ARLINGTON COUNTY, VIRGINIA
HISTORICAL AFFAIRS AND LANDMARK REVIEW BOARD
APPLICATION FOR CERTIFICATE OF APPROPRIATENESS

Name of Historic District _____
Address of Building Maywood
2210 N. Nelson St

We are requesting approval after the fact of A) a repair with a change of materials for the porch railing and B) alteration of the porch by screening it in and C) adding a gutter extension.

PROPOSED ALTERATIONS

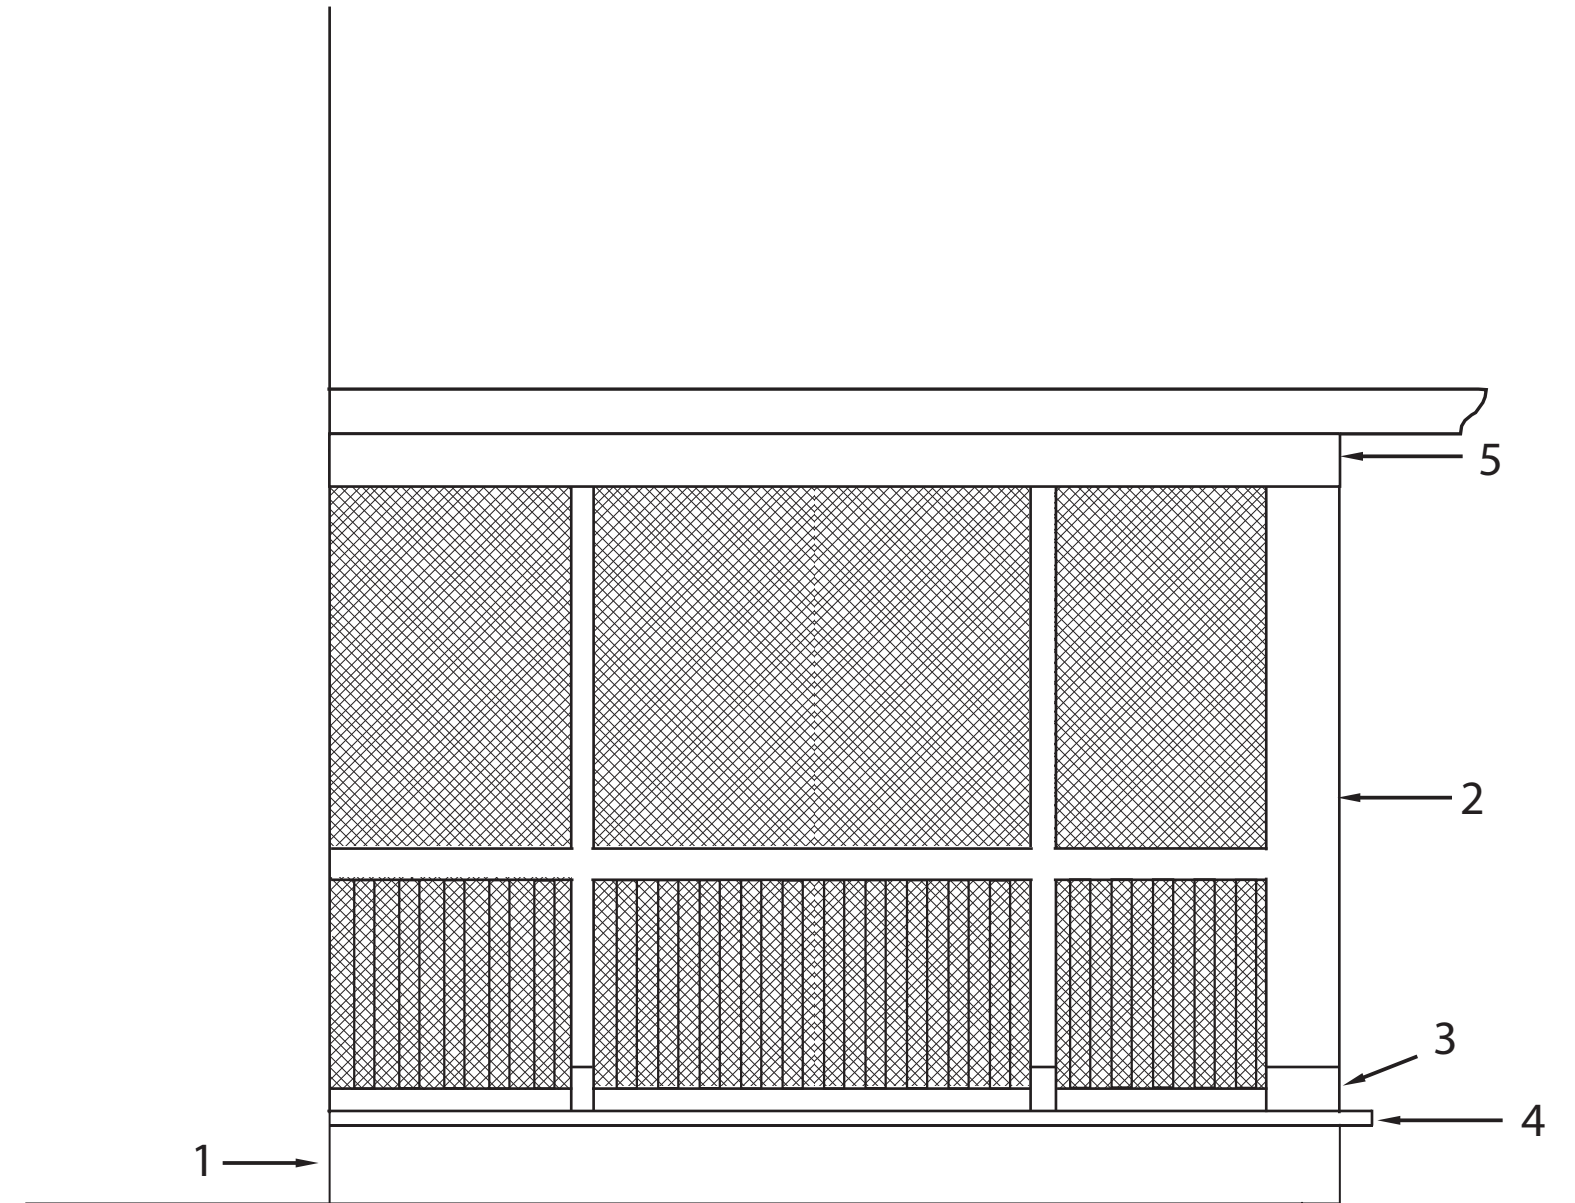
- 1 - New fascia board to cover lag bolts
- 2 - Infill of narrow screens to create a heavier corner column
- 3 - Addition of 1"x6" fascia to create a column base (will be placed at all support posts)
- 4 - Extension of decking by 4"
- 5 - New fascia board (will wrap all elevations of the porch including entry)
